Final Environmental Statement

related to the operation of
Palo Verde Nuclear Generating Station,
Units 1, 2, and 3

Docket Nos. STN 50-528, STN 50-529, and STN 50-530

Arizona Public Service Company, et al.

Figure 5.1 Potentially meaningful exposure pathways to individuals

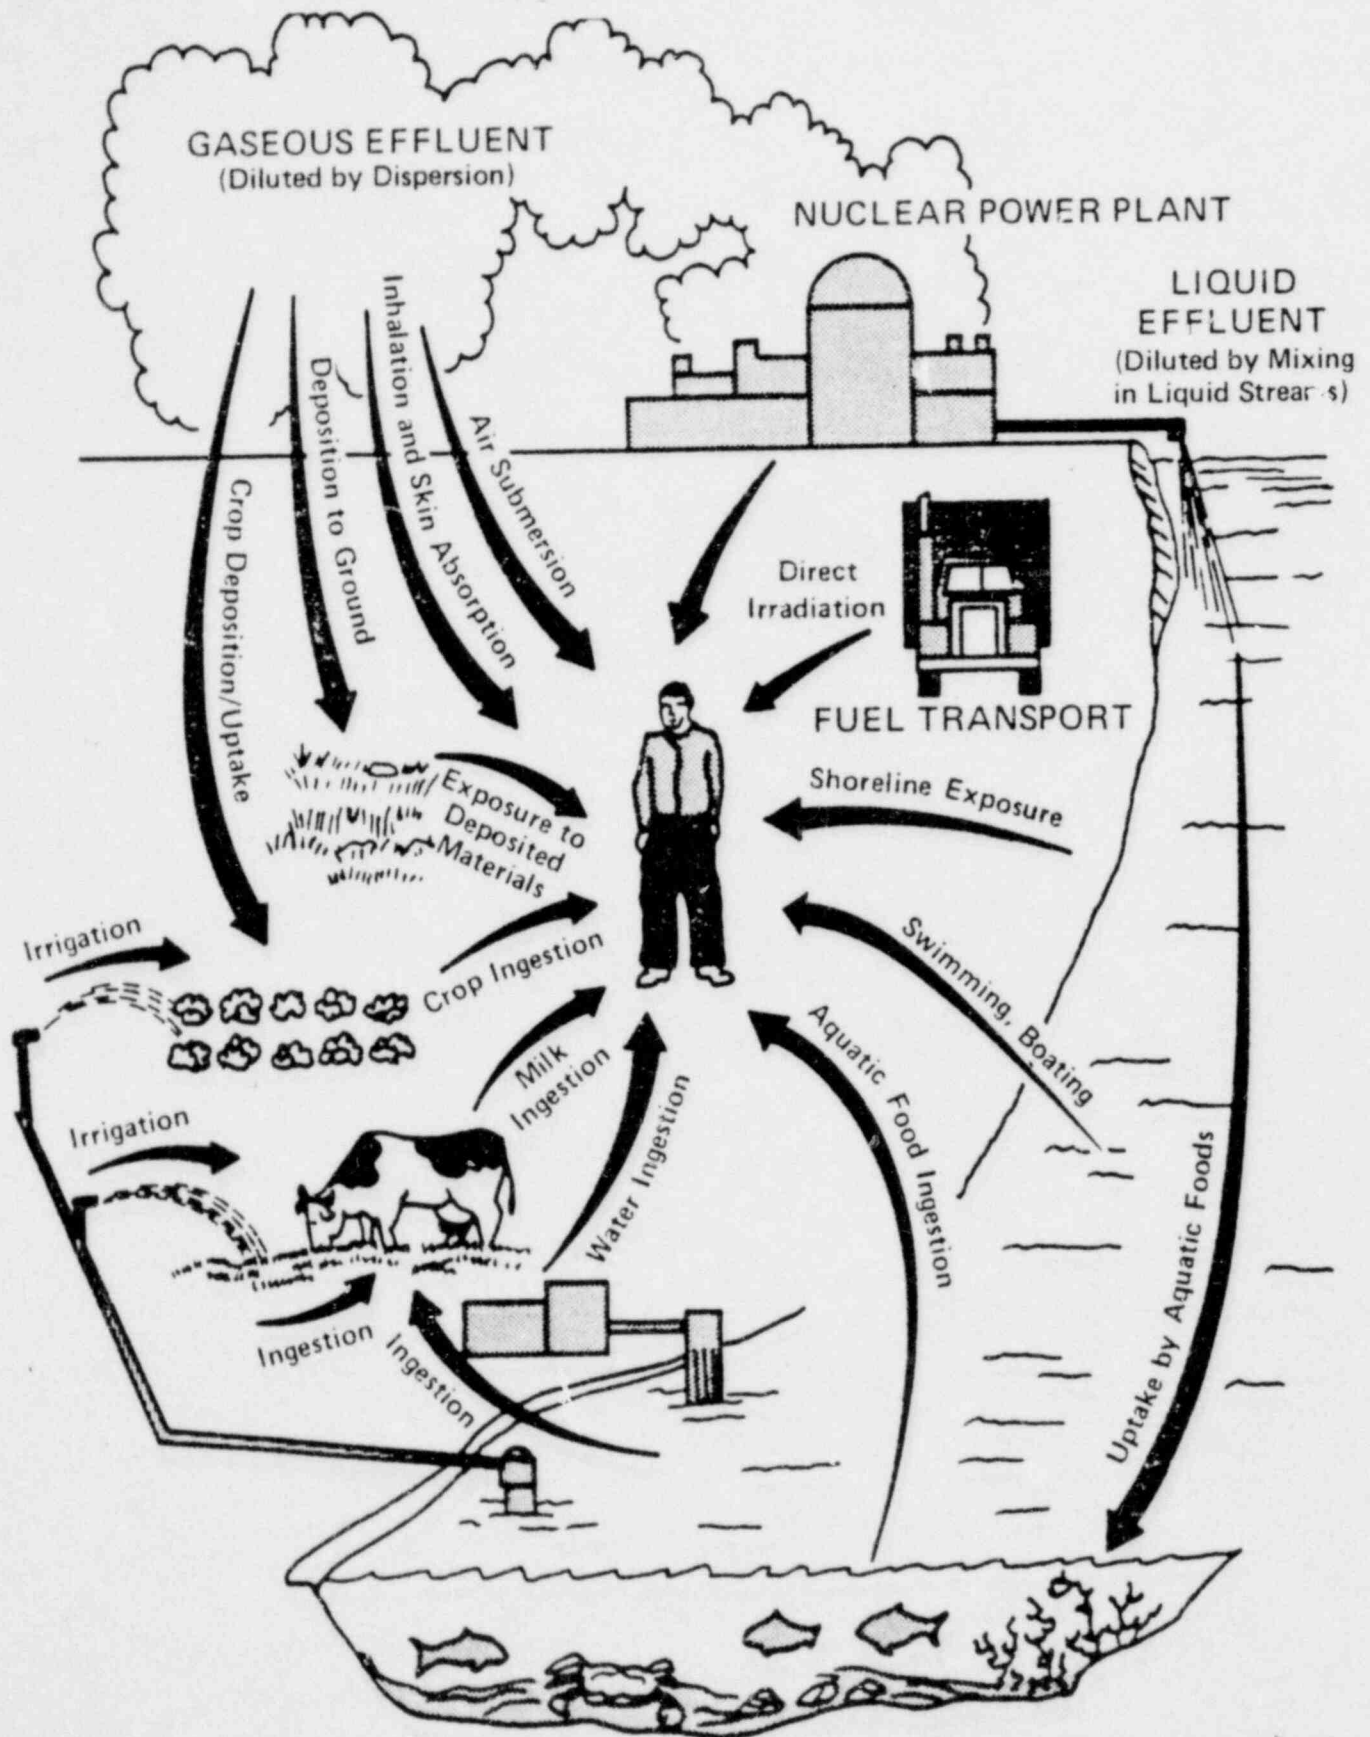
2. The environmental pathways discussed in Section 5.9.1. and shown schematically in Figure 5.1 cover all emission air pathways that could impact on the population in the environs of the facility. The dose computational methodology and models (Appendix C and D) used in the estimation of radiation doses to individuals near the plant and populations within 80 km of the plant have provided the means to calculate a reasonable estimate of the doses resulting from normal operations and accident situations at the facility. Results of these calculations are shown in Appendix C, Tables C-4, C-5 and C-6, and confirm that the calculated doses meet the design objectives.
